February 2020
SF593AB

Subject: FCCC Motorhome Chassis Fan Cages

Models Affected: Specific Freightliner Custom Chassis XCM and XCP chassis manufactured December 12, 2013, through April 16, 2019.

Fig. 3, Bolt-Together Fan Cage with Two Fan Gear Box Mounting Bolts (per bracket)

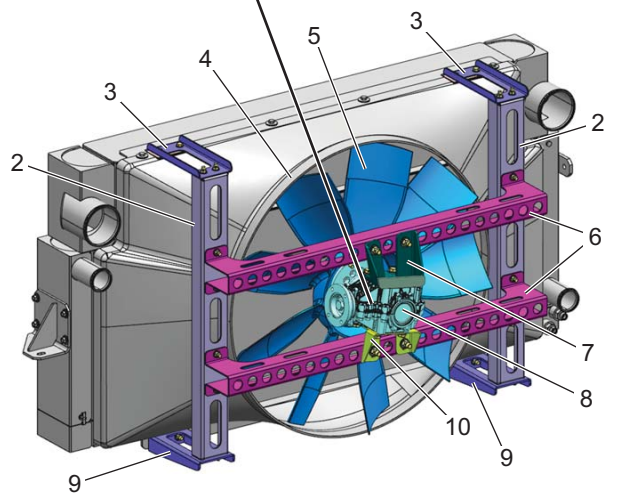
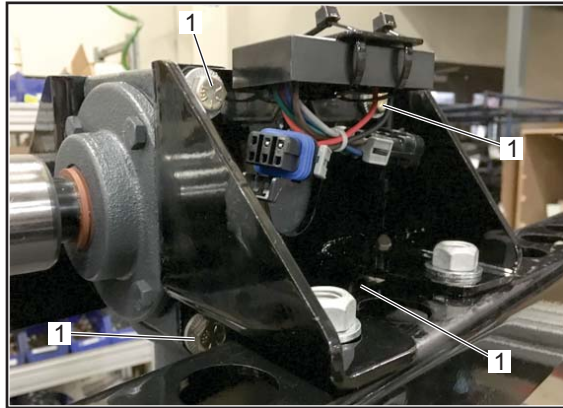
If the bottom fan gear box mounting bracket (with a flange in the center) only has two bolts that attach the fan gear box, shown in [Fig. 3](#), go to *Replacing Two-Bolt Mounted Fan Gear Box Brackets* to replace the top and bottom fan gear box mounting brackets.

If the bottom fan gear box mounting bracket only has two mounting bolts, the mounting brackets must be replaced with the fan gear mounting brackets shown in [Fig. 1](#).

1. Remove the lower horizontal bracket.
 - 1.1 Remove the bottom mounting bolts of the fan gear box.
 - 1.2 Remove the bolts that attach the lower horizontal bracket to the right and left vertical brackets; set the horizontal bracket aside.
2. Remove the fan bolts then set the fan inside the fan shroud.
3. Remove the drive shaft.
4. Remove the two bolts at the top of the gear box, then remove the gear box from the top horizontal bracket; set the gear box aside.

NOTE: Apply Loctite® 242 on the threads of all eight (new) gear box bracket bolts .

5. Remove the top and bottom two-bolt gear box mounting brackets, then install the new four-bolt mounting brackets. Tighten the mounting bolts 59 lbf-ft (80 N·m).
6. Install the gear box on the top horizontal bracket. Tighten the mounting hardware 64 lbf-ft (87 N·m).
7. Using 3/8 bolts, install the lower horizontal bracket on the vertical brackets. Tighten the bolts 26 lbf-ft (35 N·m).
8. With the bottom horizontal fan cage bracket installed, tighten the bottom mounting hardware of the gear box 64 lbf-ft (87 N·m).
9. Mount the fan to the gear box and then center the fan. Using the six bolts removed earlier, install the fan. Tighten the bolts 35 lbf-ft (47 N·m).
10. Install the driveshaft. Tighten the bolts 70 lbf-ft (95 N·m).
11. Clean a spot on the base label (Form WAR259) and attach a campaign completion sticker for SF593 (Form WAR261) indicating this work has been completed.

Fig. 1, Bolt-Together Fan Cage with Four Fan Gear Box Mounting Bolts (per bracket)

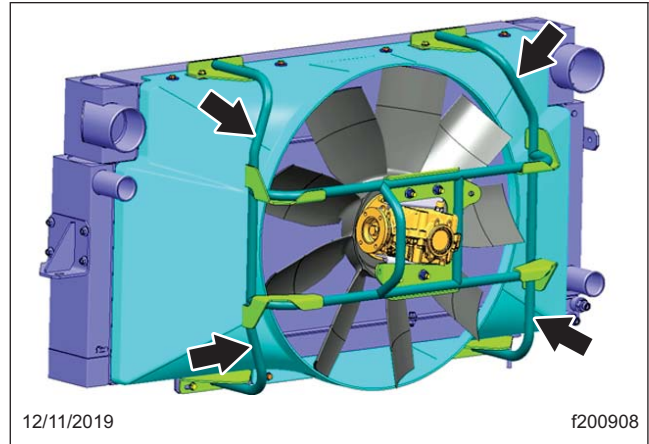
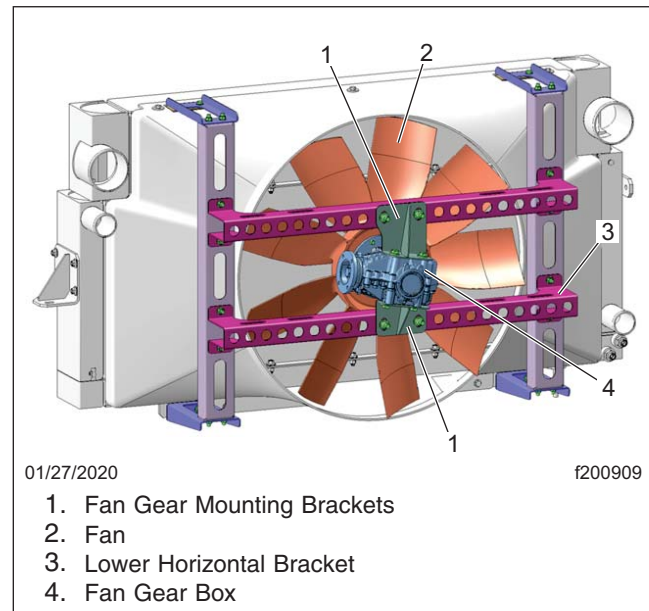
On certain chassis, fan motor support brackets may be sub-optimal causing fatigue and cracking over time. Vehicles will be inspected and fan motor support bracket assemblies will be repaired as necessary.

If the fan cage is a welded assembly, shown in [Fig. 2](#), it must be replaced. Go to *Replacing a Welded Fan Cage Assembly* for instructions.

If the fan cage is a welded assembly, as shown in [Fig. 2](#), it must be replaced with vertical and horizontal fan cage brackets, and fan gear box mounting brackets as shown in [Fig. 1](#).

- Using the 3/8 nuts and washers, install the top-left (A05-33269-000) and top-right (A05-33275-000) mounting brackets. See [Fig. 1](#). Tighten the nuts 26 lbf-ft (35 N·m).
- Using the 3/8 nuts and washers, install the two vertical fan cage brackets (05-32856-001). Tighten the nuts 26 lbf-ft (35 N·m).
- Using the 3/8 nuts and washers, install the bottom-left (A05-33270-000) and bottom-right (05-33268-000) mounting brackets. Tighten the nuts 26 lbf-ft (35 N·m).
- Using the 3/8 nuts and washers, install the top horizontal fan cage bracket (05-32855-000). Tighten the nuts 26 lbf-ft (35 N·m).

NOTE: Apply Loctite 242 on the threads of all eight gear box bracket bolts.

- Using eight new bolts (DDE N910105012007), install the top (A05-34854-000) and bottom (A05-34950-000) brackets on the gear box. Tighten the bolts 59 lbf-ft (80 N·m).

- Install the gear box on the top horizontal fan cage bracket. Tighten the mounting hardware 64 lbf-ft (87 N·m).
- Using the 3/8 nuts and washers, install the bottom horizontal fan cage bracket (05-32855-000). Tighten the nuts 26 lbf-ft (35 N·m).

- With the bottom horizontal fan cage bracket installed, tighten the bottom mounting hardware of the gear box 64 lbf-ft (87 N·m).
- Mount the fan to the gear box and then center the fan. Using the six bolts removed earlier, install the fan. Tighten the bolts 35 lbf-ft (47 N·m).
